Addendum No. 03

June 9, 2026

Parlier HS Stadium Replacement

PBK PROJECT NO.: 250093
DSA FILE NO.: 10-H12
DSA APPLICATION NO.: 02-124002 _ PARLIER HS STADIUM REPLACEMENT

B ADD ALTERNATIVE DEDUCTION 6
CS3.2 1" = 20'

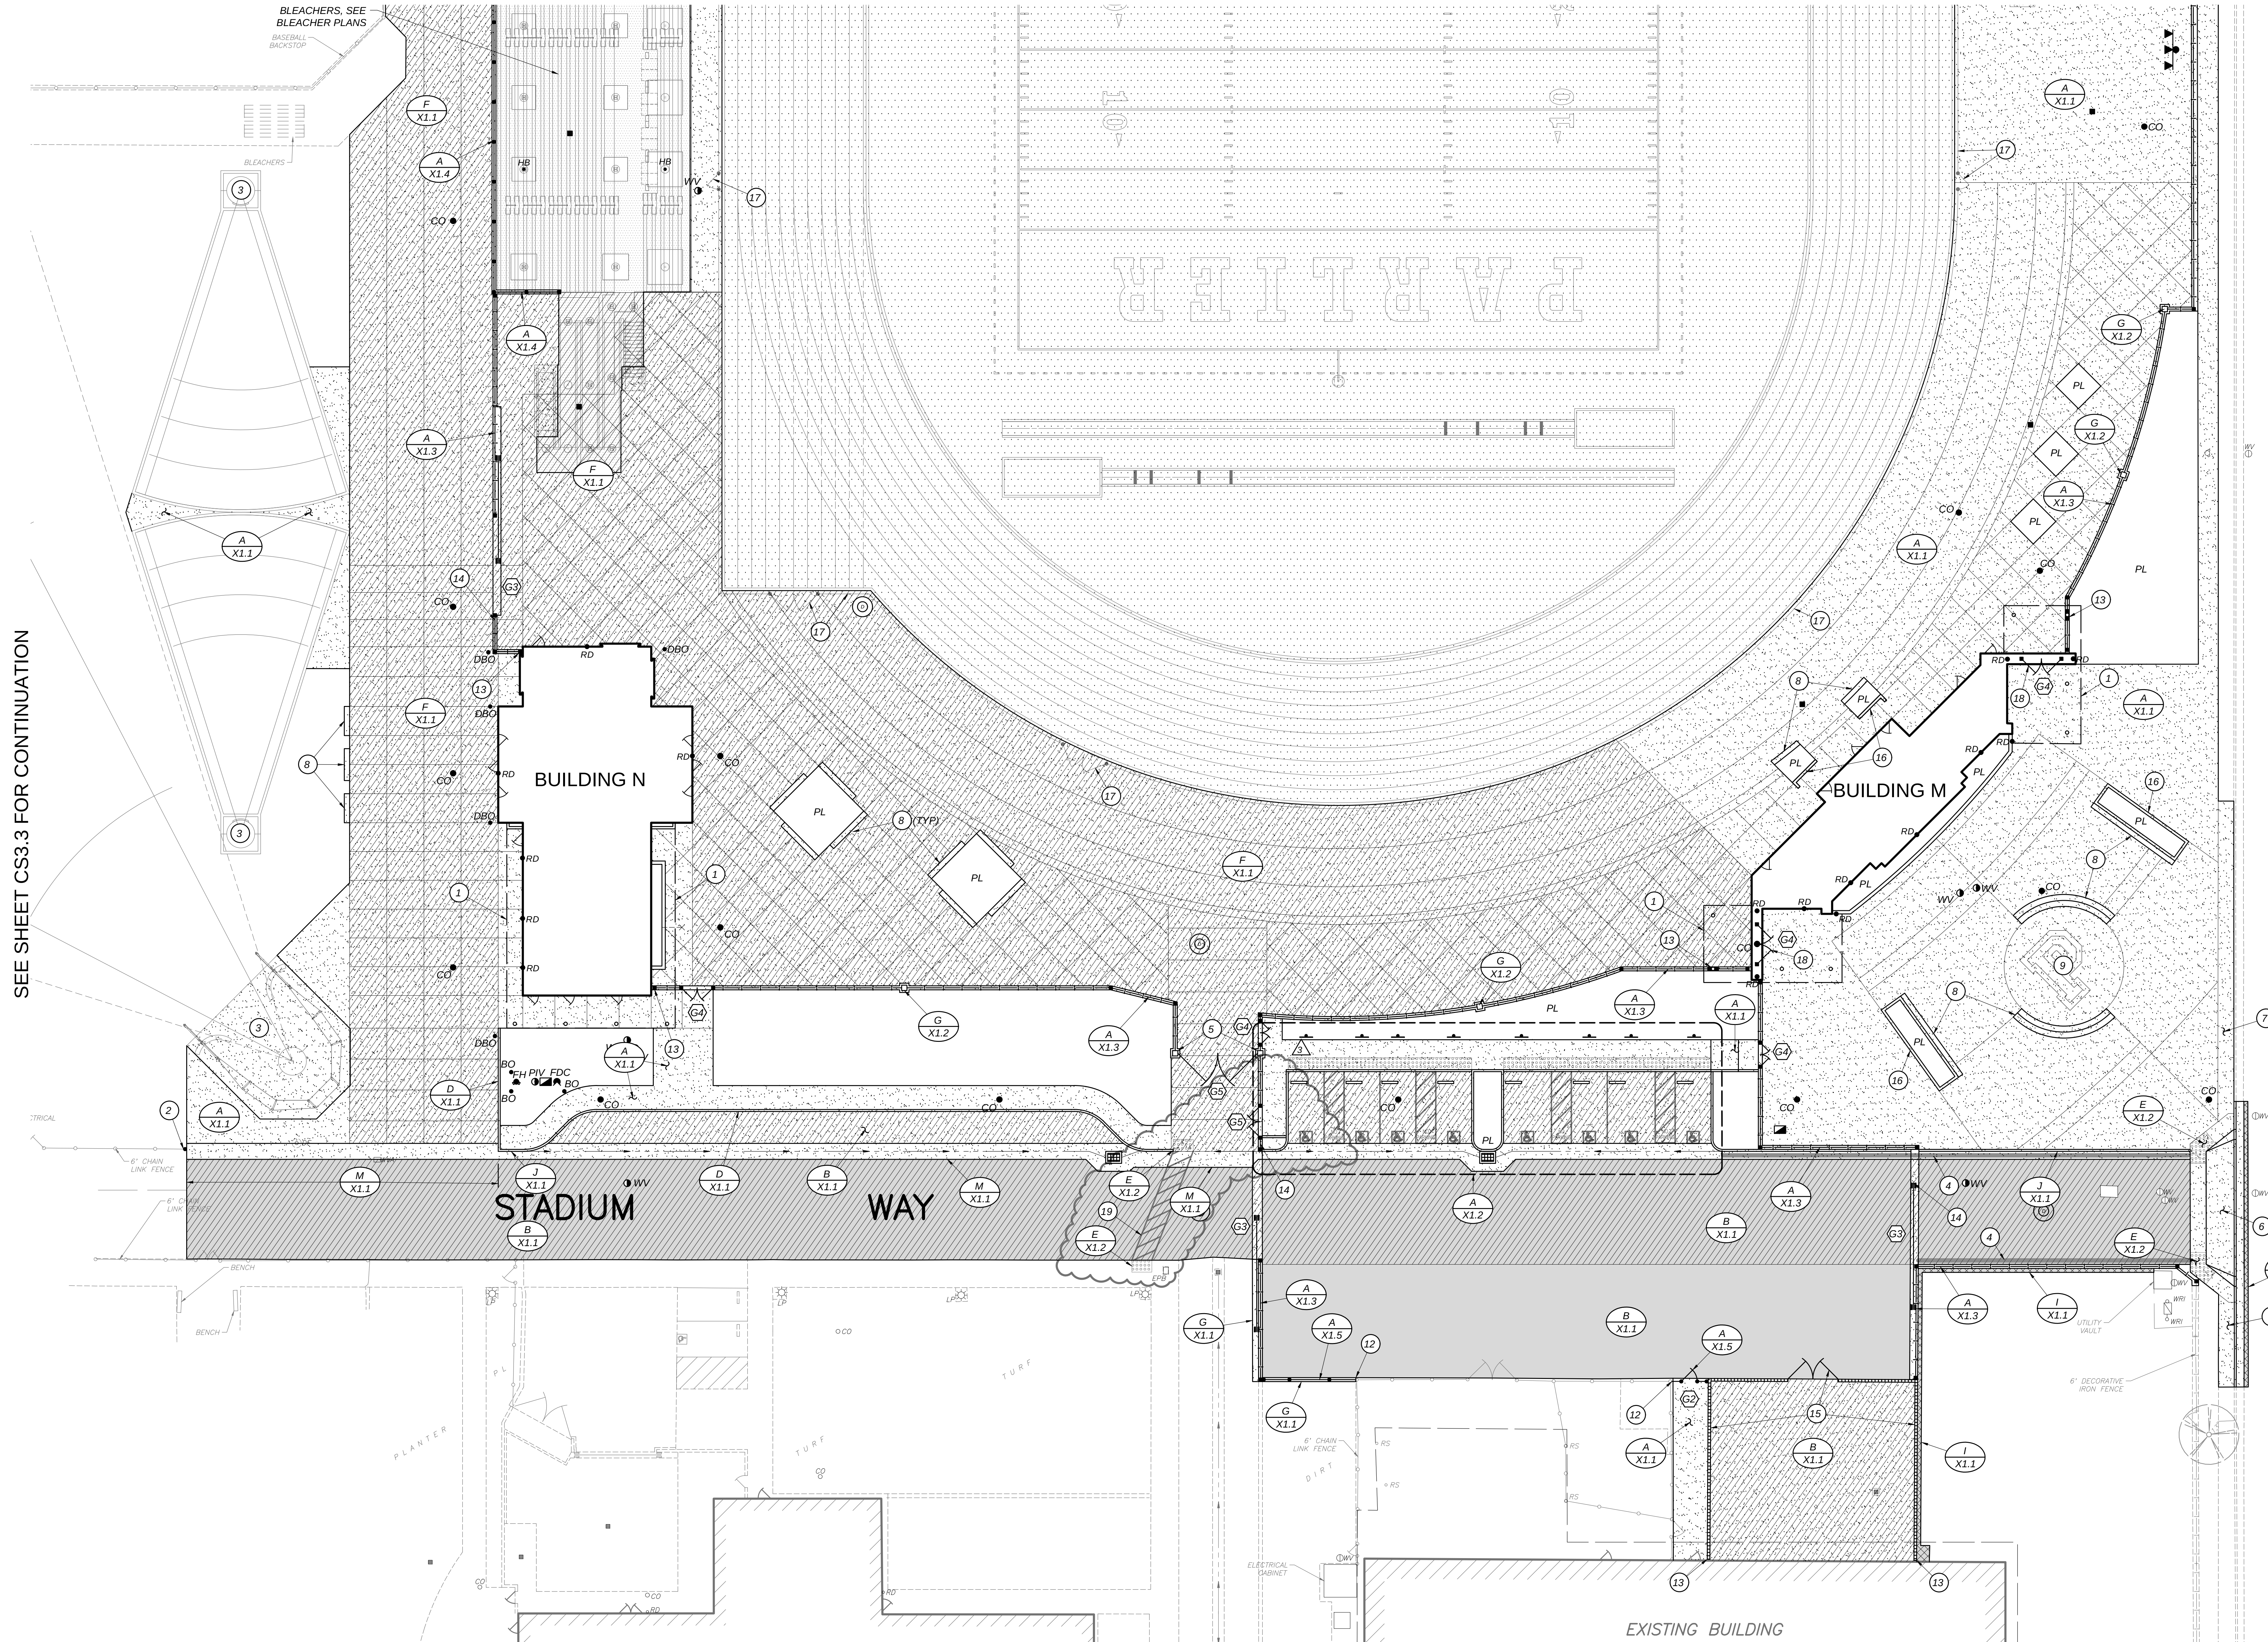
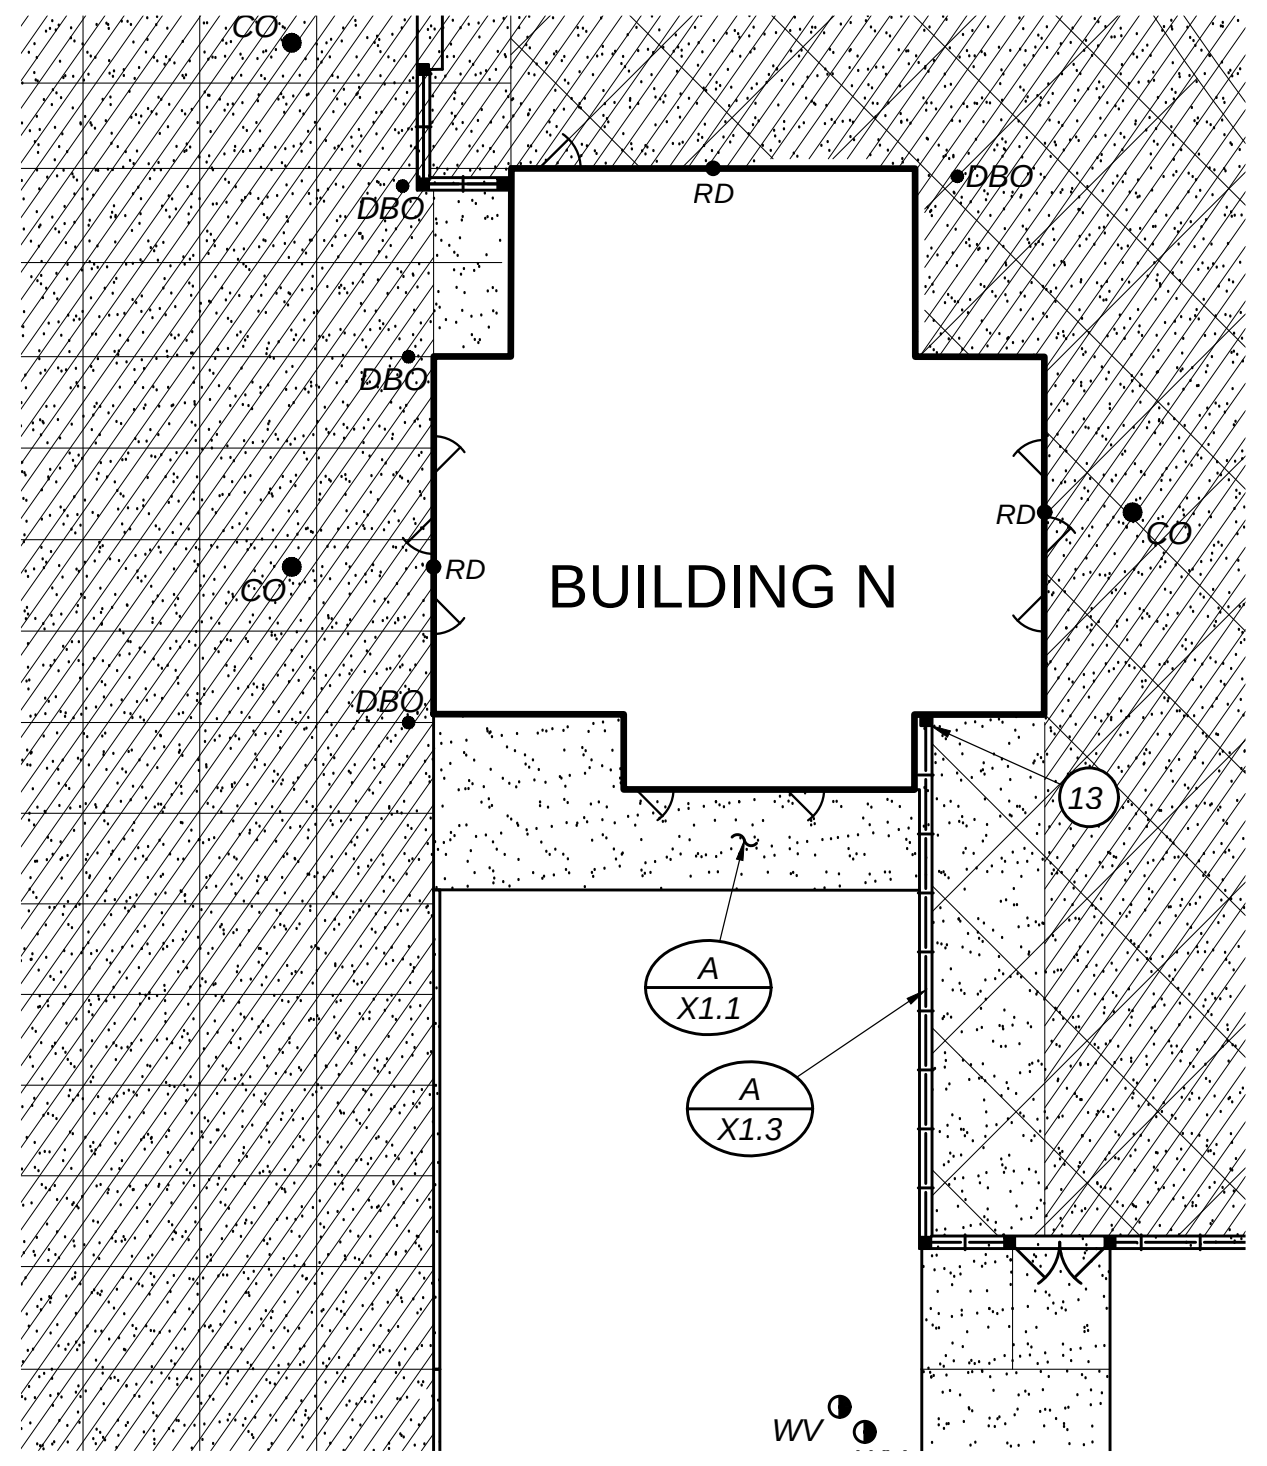
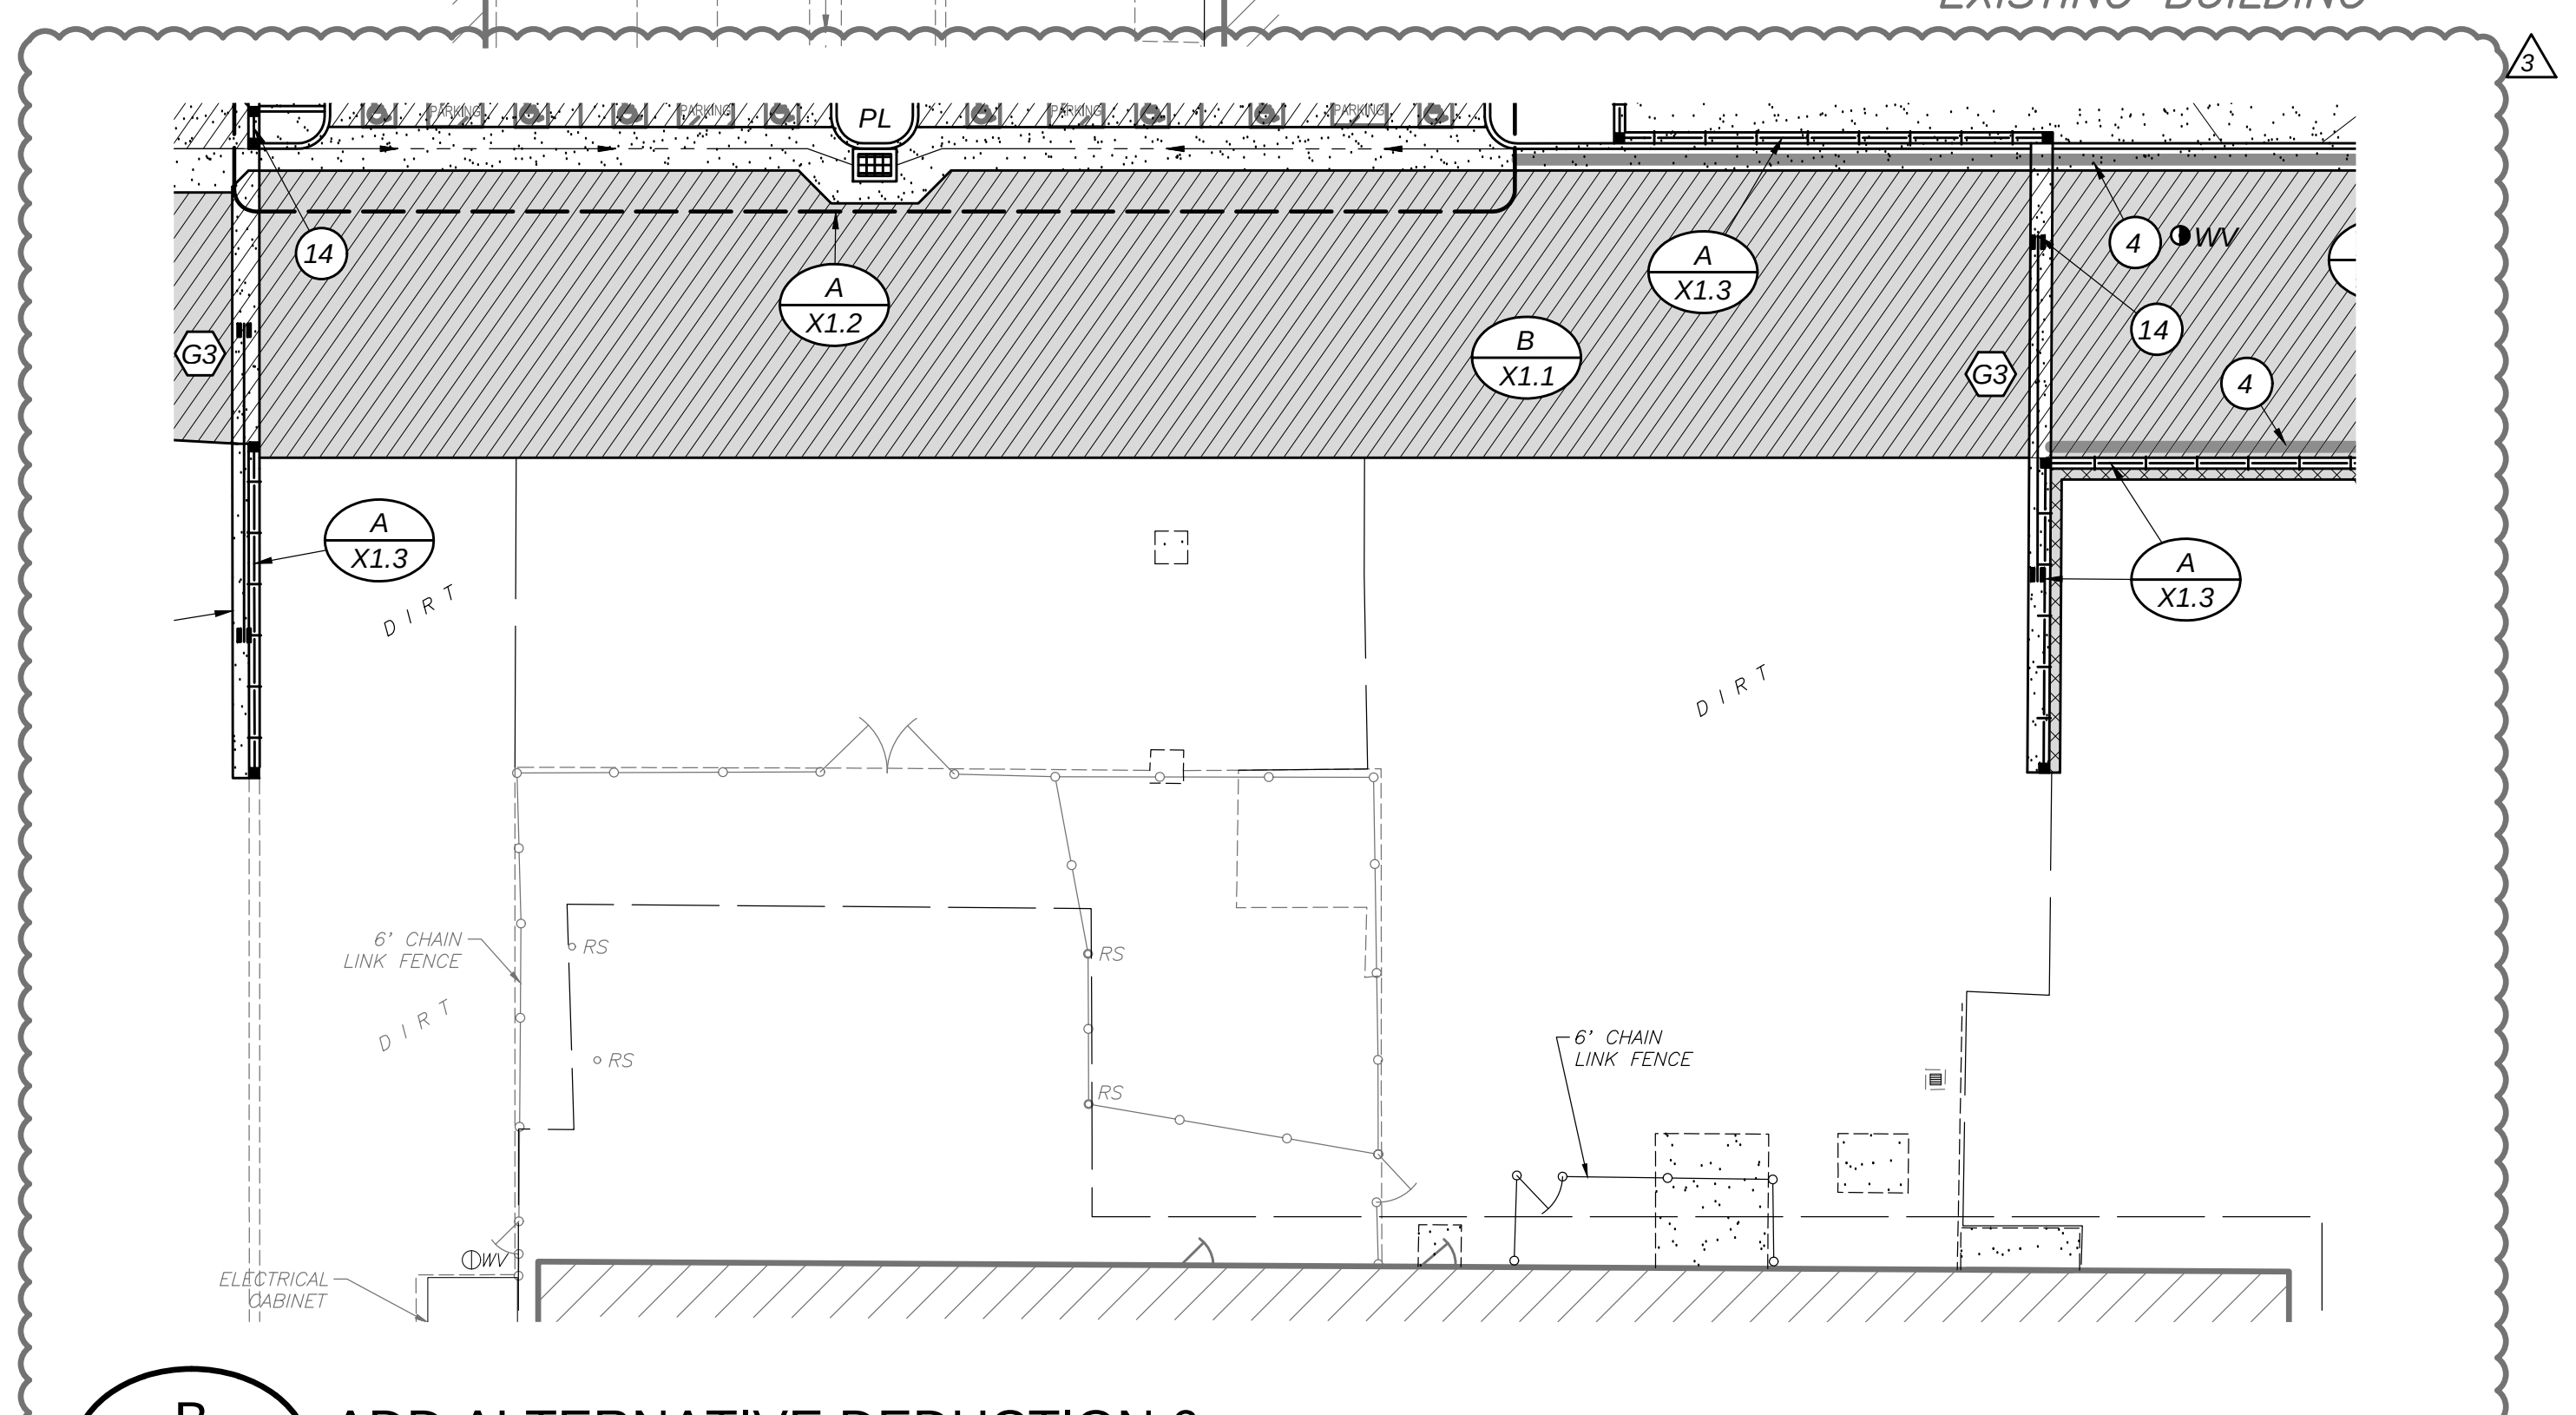
5. Refer to sheet CS3.2 “PARTIAL SITE PLAN”
    a. Remove and replace sheet CS3.2 “PARTIAL SITE PLAN” with herein attached sheet CS3.2 “PARTIAL SITE PLAN” identified with AD3 on the bottom right-hand corner.

- Revised legend and callouts.
- Added Alternative Deduction 6
- Added double gate, striping, and concrete.
